STATE OF CONNECTICUT
CONNECTICUT SITING COUNCIL

APPLICATION OF CELLCO PARTNERSHIP)	
d/b/a VERIZON WIRELESS FOR A)	
CERTIFICATE OF ENVIRONMENTAL)	DOCKET NO. 413
COMPATIBILITY AND PUBLIC NEED FOR THE)	
CONSTRUCTION, MAINTENANCE, AND)	
OPERATION OF A WIRELESS)	April 14, 2011
TELECOMMUNICATIONS FACILITY LOCATED AT)	
723 LEETES ISLAND ROAD IN THE TOWN)	
OF BRANFORD, CONNECTICUT)

NEW CINGULAR WIRELESS PCS, LLC ("AT&T")
RESPONSES TO TOWN OF BRANFORD INTERROGATORIES

ATTACHMENT 5

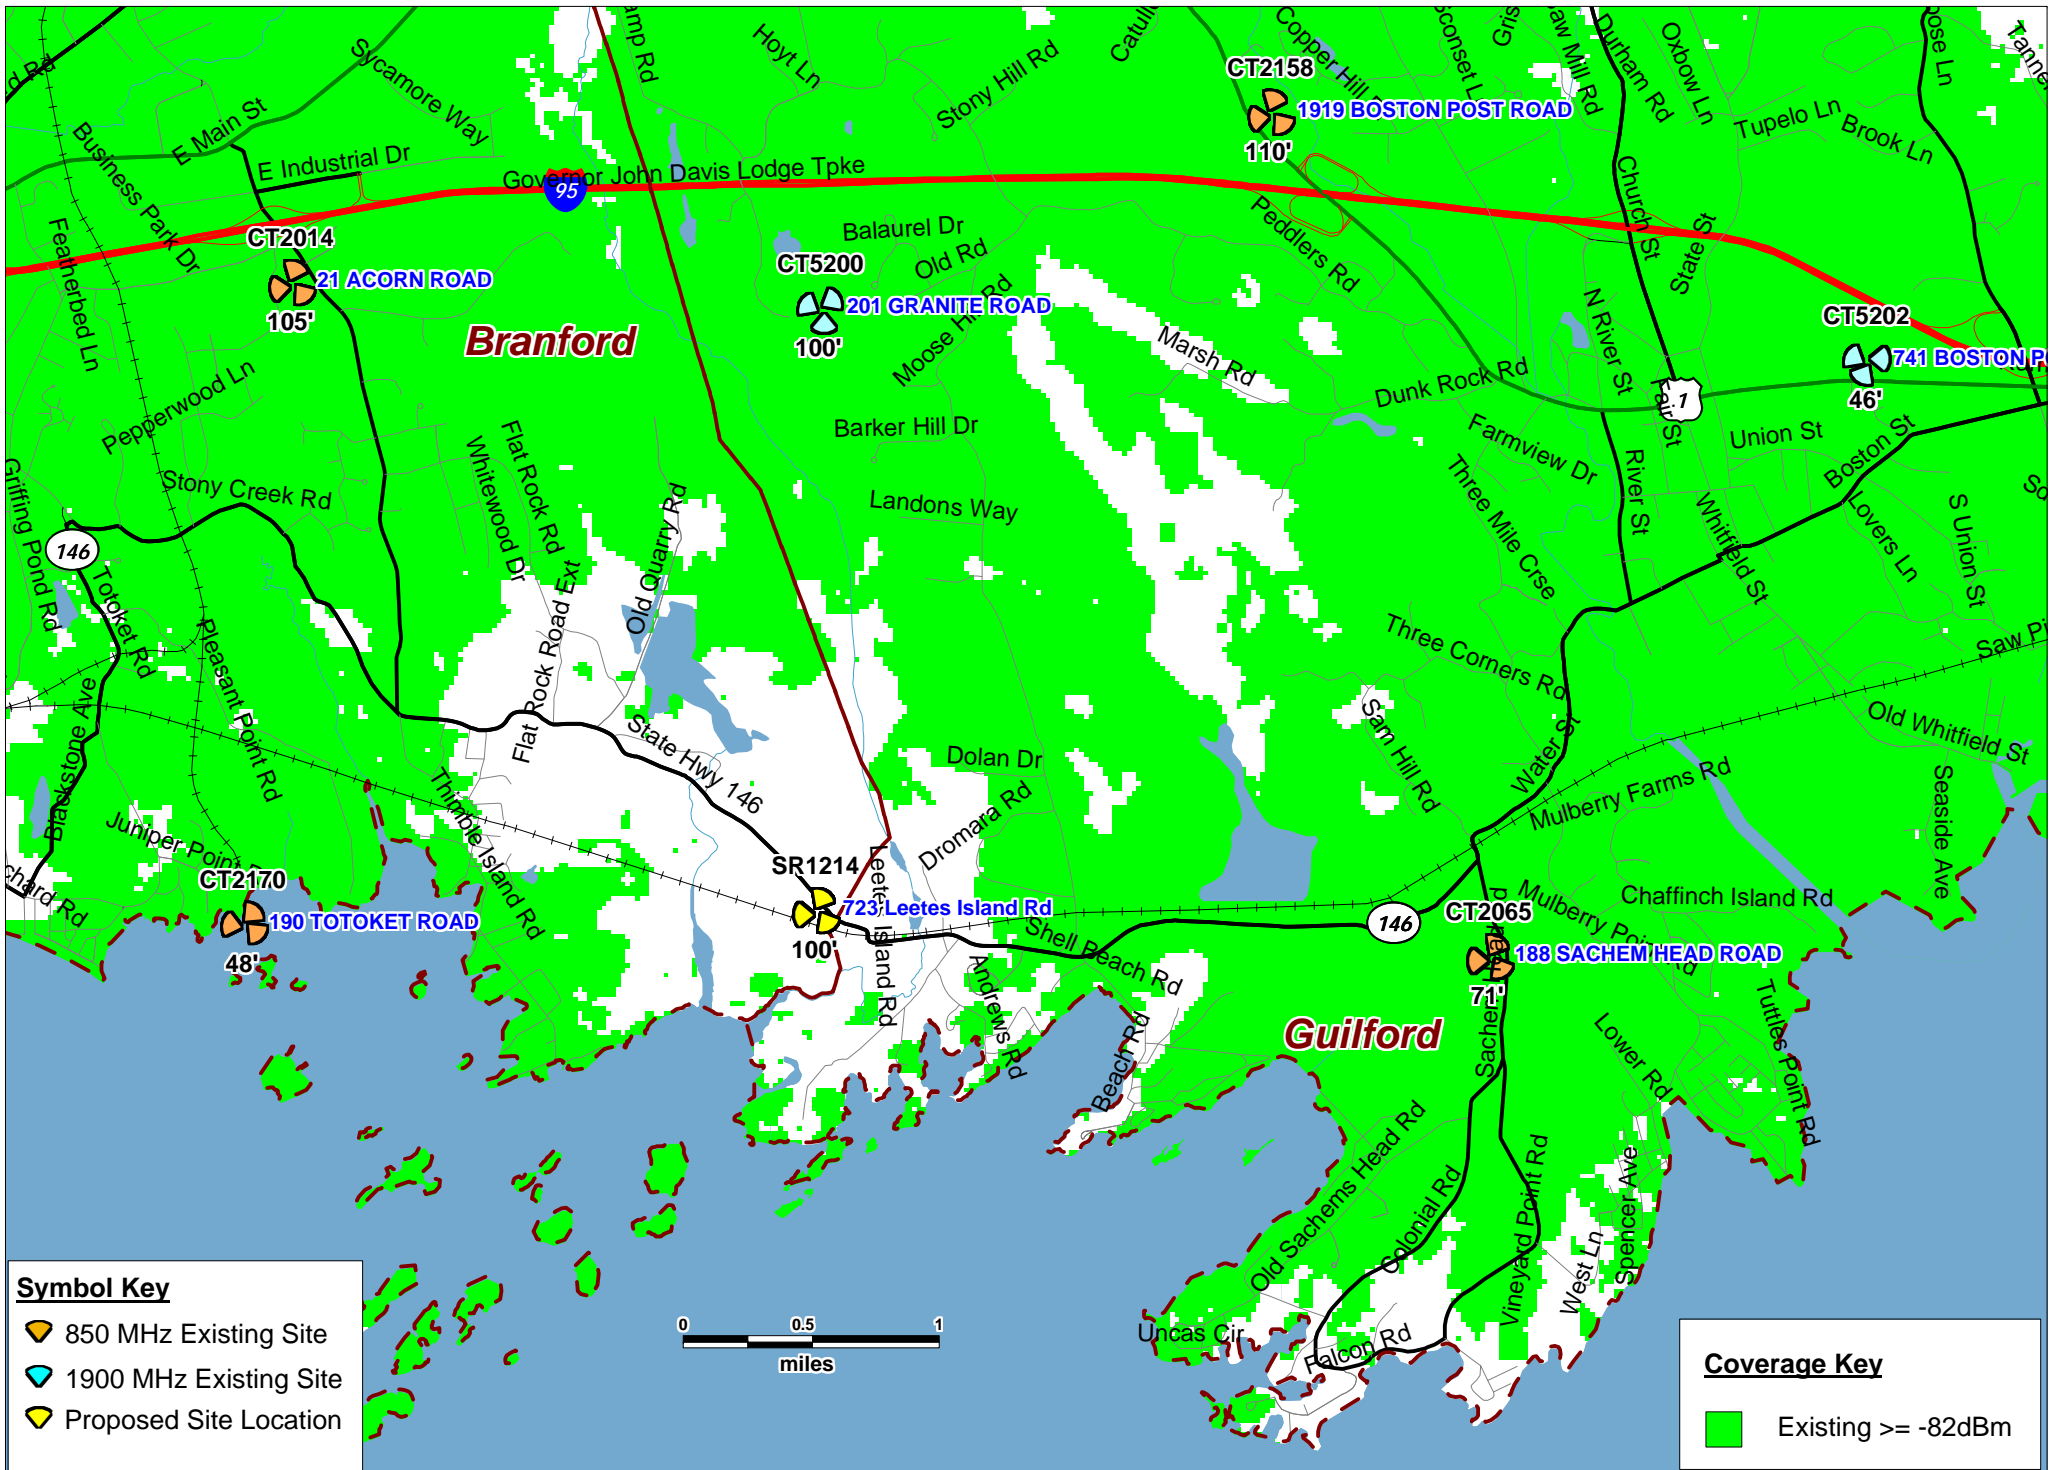
A34. Can you provide separate proposed and existing coverage maps depicting the coverage from the target levels up to -88dBm with the levels at -3dBm intervals (e.g.: -74 to -77dBm, -77dBm to -80dBm, etc)?

A34. The requested plots are included in Attachment 4.
